**Stage 1/2 Road Safety Audit
Proposed Residential Development,
Stradbally Road, Portlaoise, Co. Laois**

Client:	Hayes Higgins Partnership
Document No:	240130-ORS-XX-XX-RP-TR-13g-001

Job: 240130 – Proposed Residential Development, Stradbally Road, Portlaoise, Co. Laois

Problem No.01: Sightlines East and West

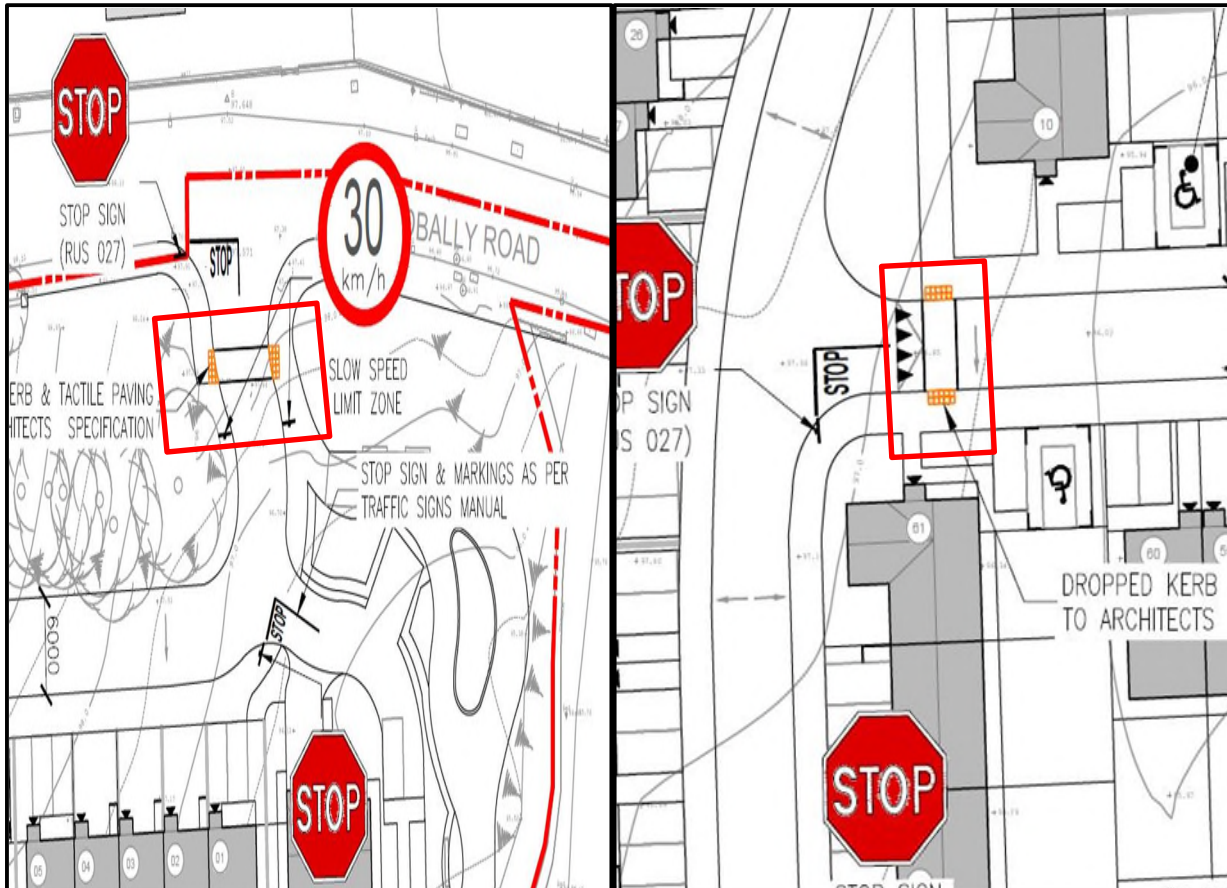
Location: Main Entrance to the Development.

The audit team note that there are sightlines detailed on the proposed drawings for the development. However, on the day of the site visit it was noted that utility poles and boundary walls are within the line of sight of vehicles exiting the development reducing visibility to the east and west. The audit team is concerned that inadequate sightlines and stopping distances could lead to sideswipe, side impact, or rear end shunt type collisions.

The design team should ensure that clear visibility is provided in both directions and that visibility envelopes are clear of any obstacles such as street furniture and boundary walls.

Problem No.3: Restricted Car Parking Spaces

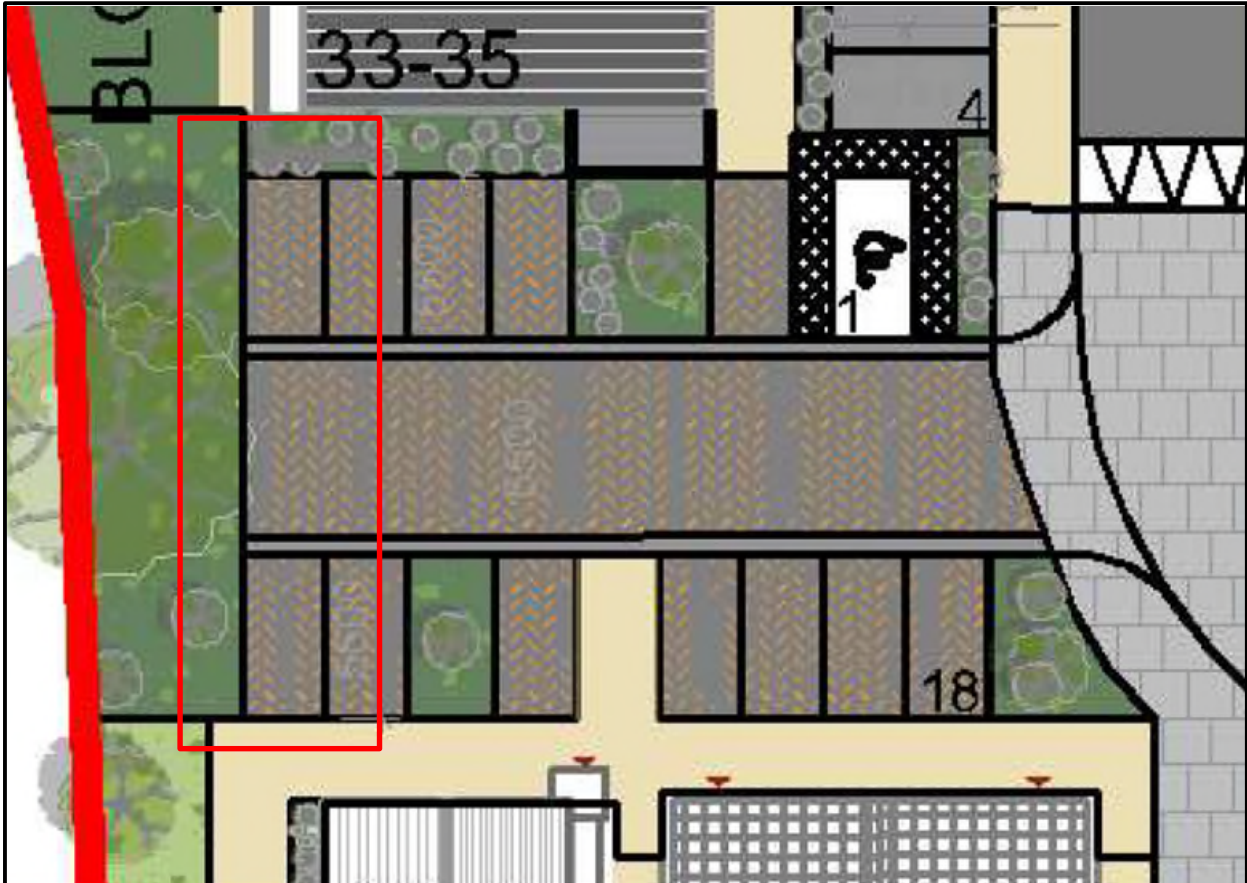
Location: Adjacent to Property No. 33 & 36

The audit team note from the drawings that parking space to adjacent to the identified properties appear to be limited in space and could be difficult for users to access given their restricted nature. This could increase the risk of potential conflicts among vehicles or vehicles conflicts with pedestrians as users may have to reverse excessive distances to exit the spaces.

The design team should review the geometry of these parking spaces to ensure that vehicles can safely enter and exit.

Problem No.4: Corner Radii within the Scheme

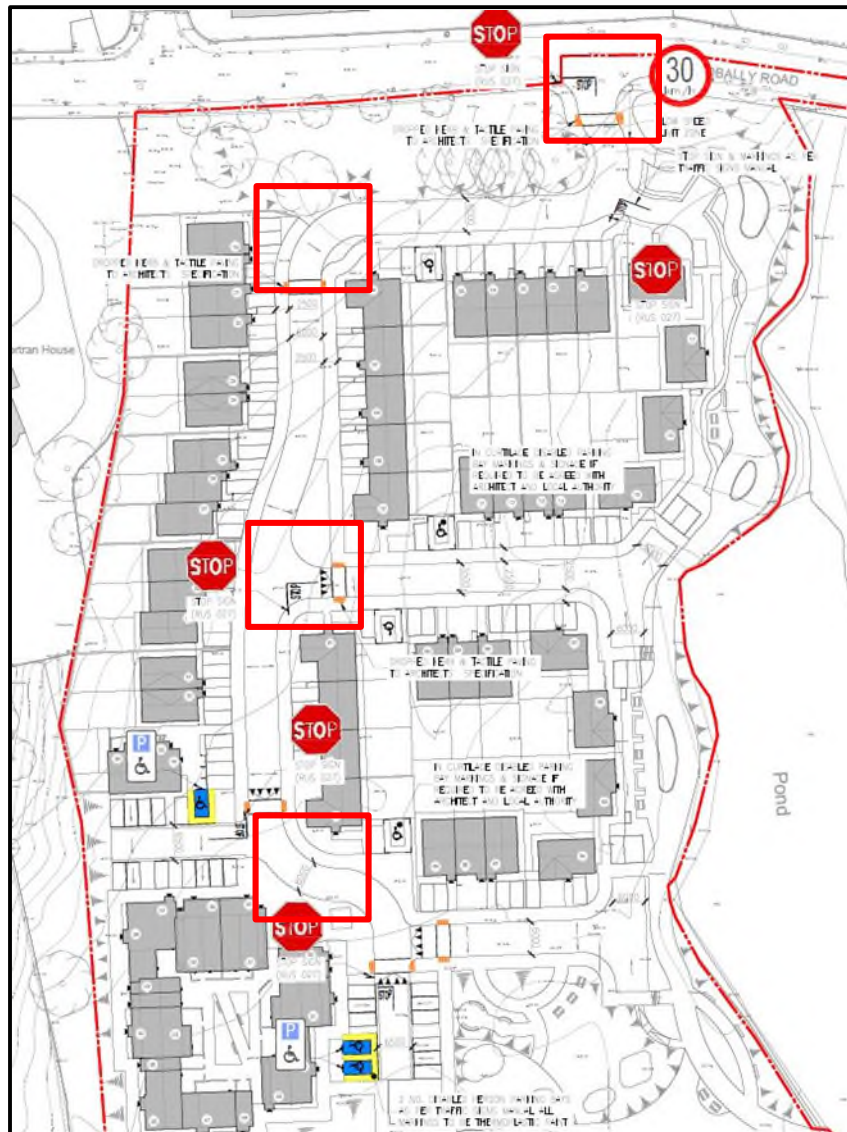
Location: Within Scheme

The audit team note from the drawings provided that the corner radii appear to be excessive which could increase the potential for higher vehicle speeds within the development. The audit team has concerns, that vehicles would not be encouraged to slow down and could result in collisions with vulnerable road users at the uncontrolled crossing.

The design team should ensure that the corner radii is appropriate for the design speed to slow vehicles down.

Problem No.5: Delineation/Visual Contrast of Driving Area

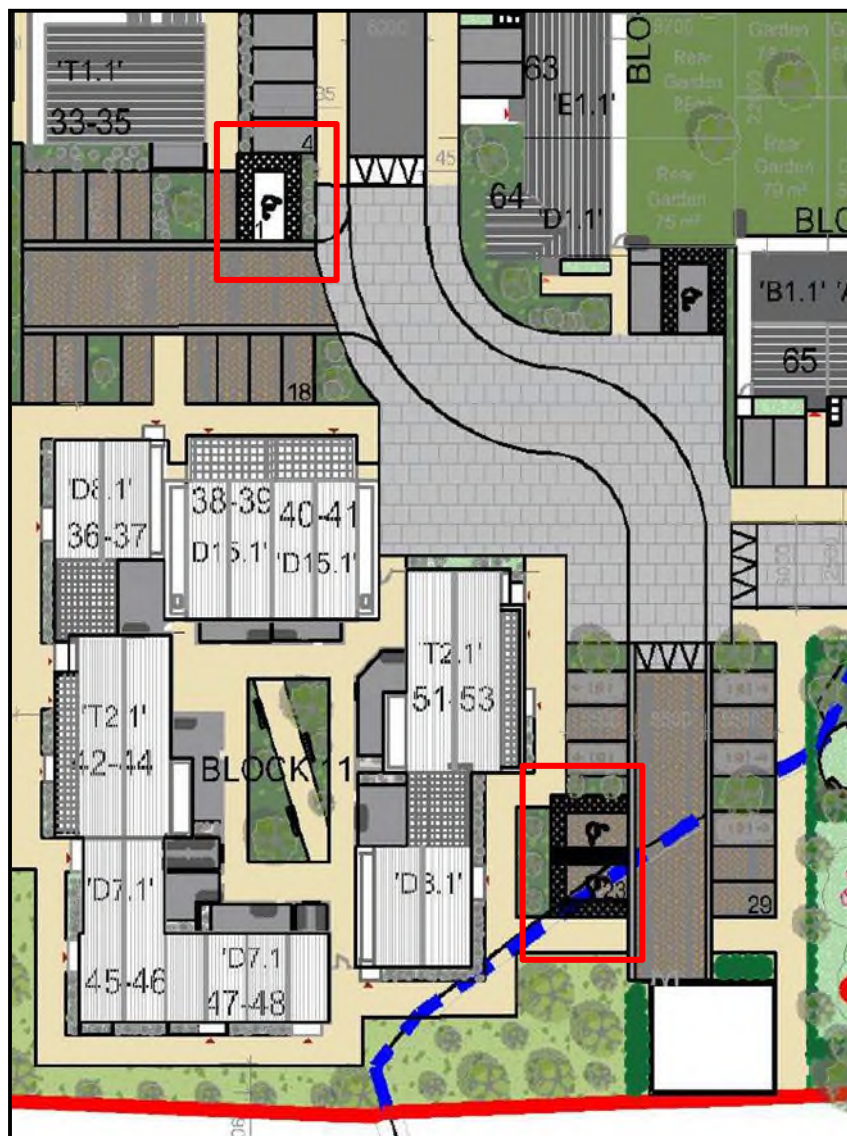
Location: Location Identified

The audit team note from the drawings provided that the area identified is fully paved with access to a disabled car parking space to the north. It is not clear if a kerb line will be provided and if it is how, it visually contrasts with the paving installed. The audit team has concerns that motorists may be given the impression that the carriageway is wider which could lead to vehicles driving in areas meant for vulnerable road users and could result in collisions with vulnerable road users. There is also a risk of illegal parking in this open area which increases the safety risk for vulnerable users.

The design team should ensure that the area provided with appropriate road marking/signage and that the colour contrast of materials between any footpath/ kerbing such that clear distinction can be made between the carriageway and footpath area. The design team should also provide hard measures in the open space to mitigate the risk if illegal parking.

Problem No.7: Gully Location

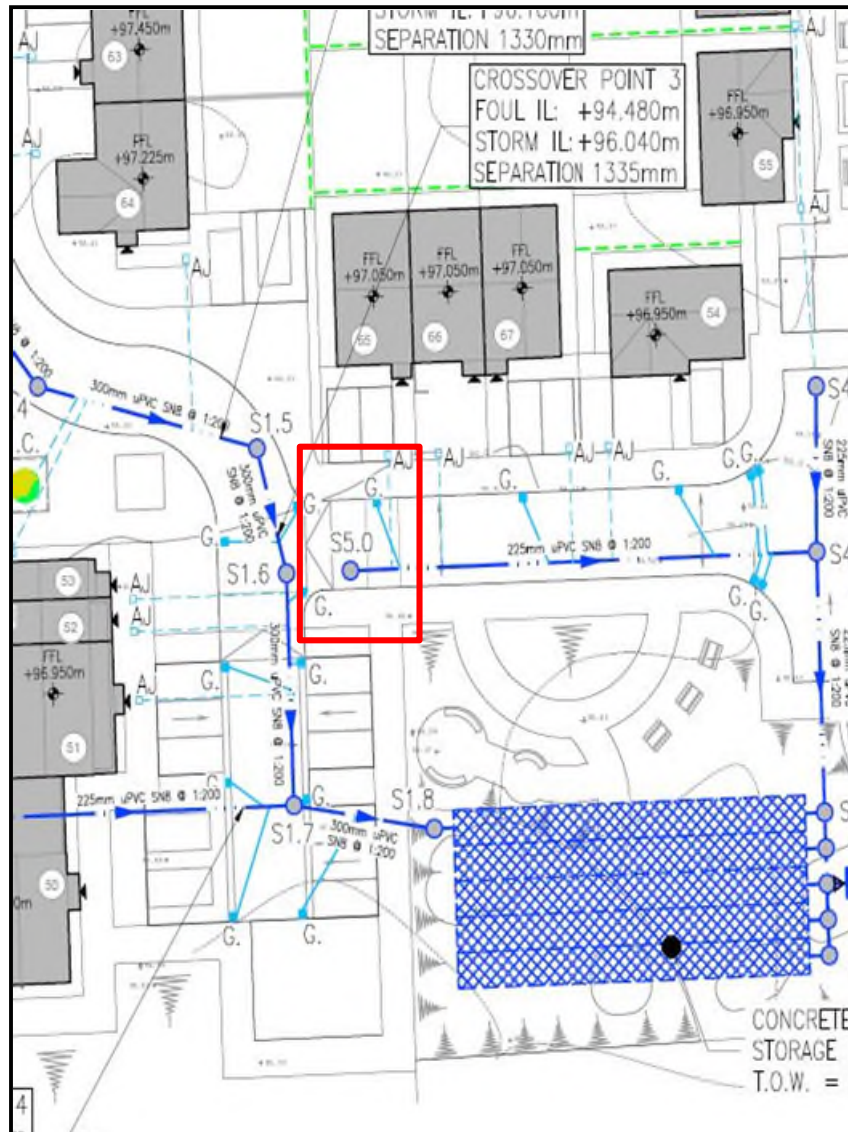
Location: Uncontrolled Crossing to the front of No. 65

The audit team note from the storm drainage drawings provided, that there appears to be a gully positioned in the line of the uncontrolled crossing. The audit team are concerned that the gullies positioned in the uncontrolled crossing line would cause slips, trips and falls to vulnerable road users.

The design team should position gullies out of the line of crossings.

Problem No.10: Protection to Pond to the East

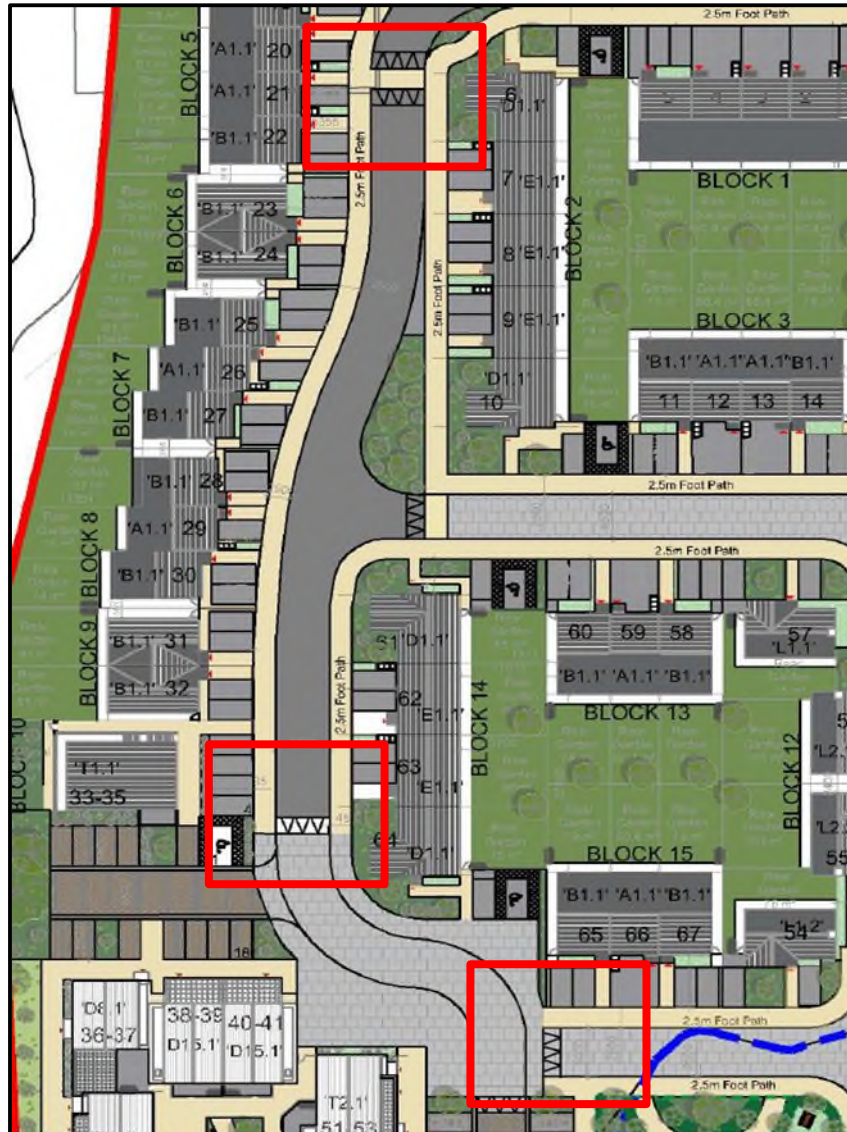
Location: Pond to the East

The audit team note that there is a pond that runs parallel to pedestrianised surface which could be a high footfall area for children in particular. As no protection is provided for vulnerable users, the audit team has concerns that a vulnerable road user could inadvertently enter the pond area which could result in potential drowning incidents.

The design team should provide adequate protection to the pond and any protruding pipework is provided to prevent vulnerable users from entering the pond area.
